Origination Form Proposed Revisions to a Standard Plans Index

Originator:	Stutts, Dylan	Index Number:	700-010
Date:	6/27/2024	Sheet Number(s):	1, 7
E-mail:	Dylan.Stutts@dot.state.fl.us	Index Title:	SINGLE COLUMN GROUND SIGNS

GENERAL NOTES AND DESIGN EXAMPLE

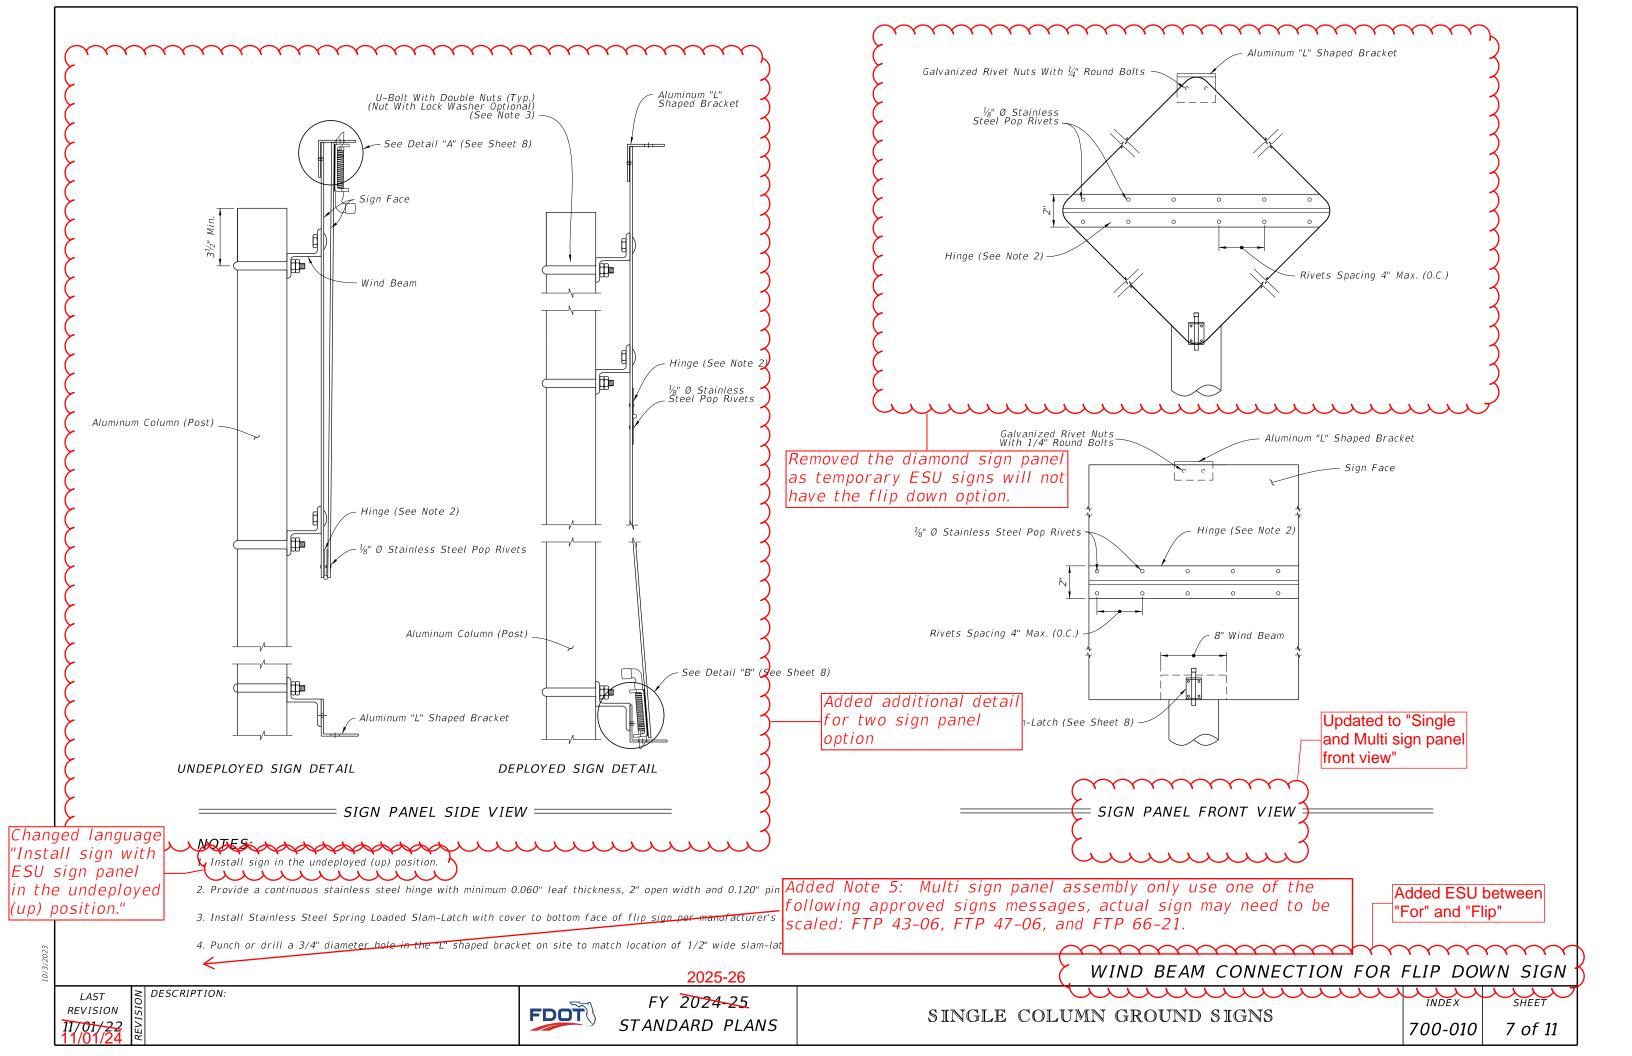
Sheet 1: Updated Table of Contents

UPDATED to Wind Beam Connection for **ESU Flip Signs**

SHEET	CONTENTS
1	General Notes and Design Example
2	Design Example – Centroid
3	Column and Foundation Tables
4	Slip Base and Foundation Details
5	Driven Post, Concrete Stub, and Soil Plate Details
6	Wind Beam Connection
7	Wind Beam Connection for ESU Flip Signs
8	Slam-Latch Detail
9, 10, & 11	Frequently Used Sign Clusters

WIND BEAM CONNECTION FOR ESU FLIP SIGNS

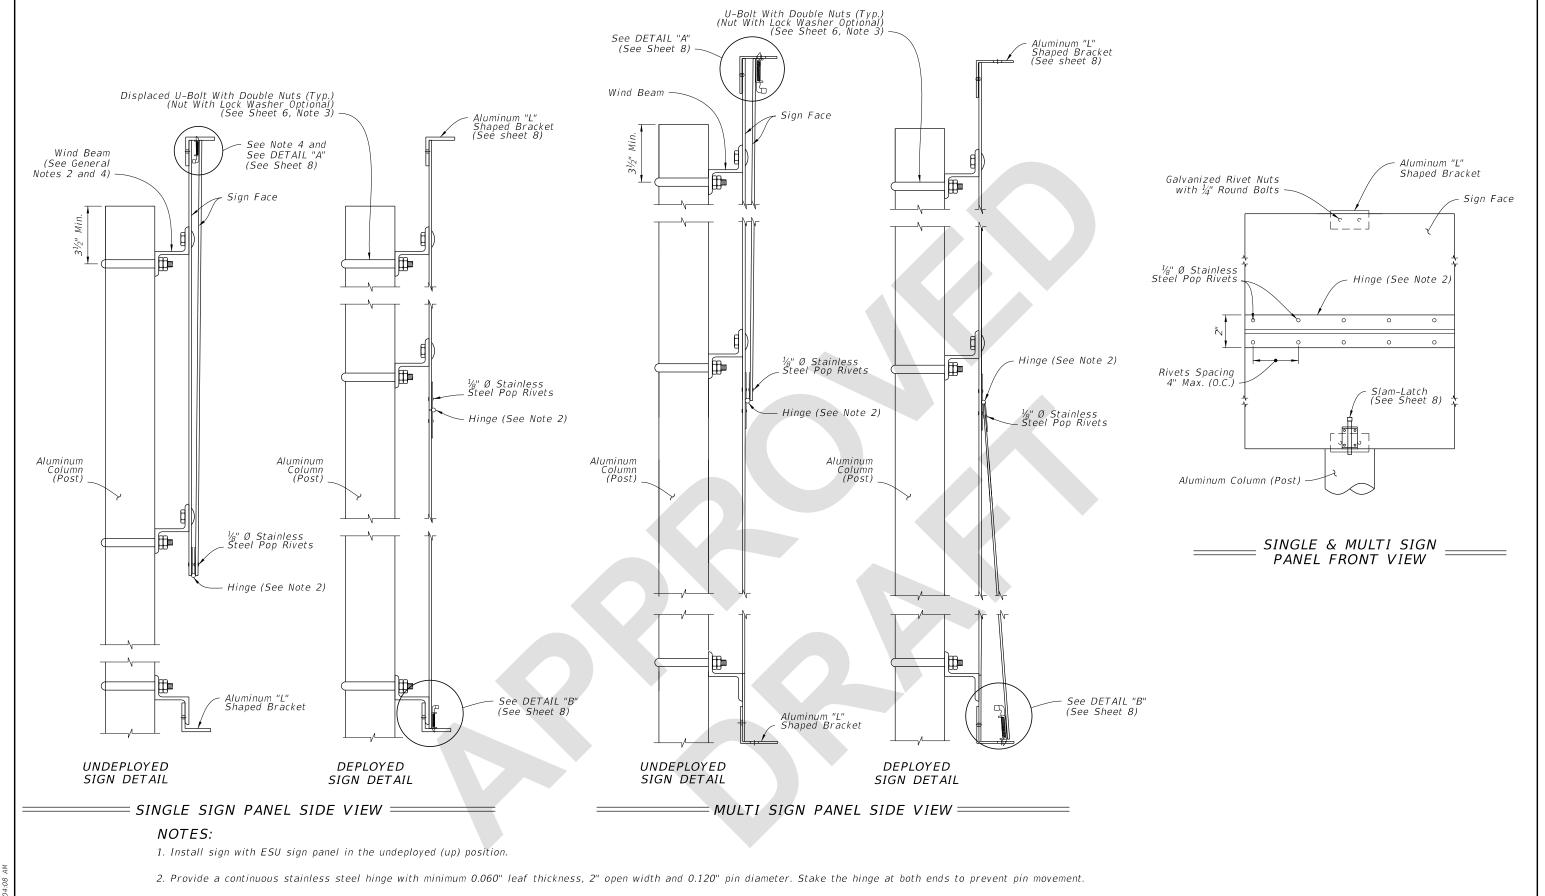
Sheet 7: Updated the flip sign to allow for multiple sign panels; Removed the diamond sign panel; Updated Note 1 to "Install sign with the ESU sign panel in the undeployed (up) position."; Added Note 5 "Multi sign panel assembly only use one of the following approved signs, actual sign may need to be scaled: FTP 43-06, FTP 47-06, and FTP 66-21."; Added ESU to sheet title

The changes are coming from head of CO Traffic ops based on request from DTOEs to allow for multiple sign panels on the ESU flip sign. Updated the Standard Plan to allow for two sign panels which were approved by CO Traffic Ops. During ESU meeting districts request the use of static sign while ESU sign was not deployed. Removed the diamond sign panel as this is not used for permanent ESU signs.

- 3. Install Stainless Steel Spring Loaded Slam-Latch with cover to bottom face of flip sign per manufacturer's recommendations.
- 4. Punch or drill a 3/4" diameter hole in the "L" shaped bracket on site to match location of 1/2" wide slam-latch pin. Remove any burs or sharp edges.
- 5. Multi sign panel assembly only use one of the following approved sign messages, actual sign may need to be scaled: FTP 43-06, FTP 47-06, and FTP 66-21.
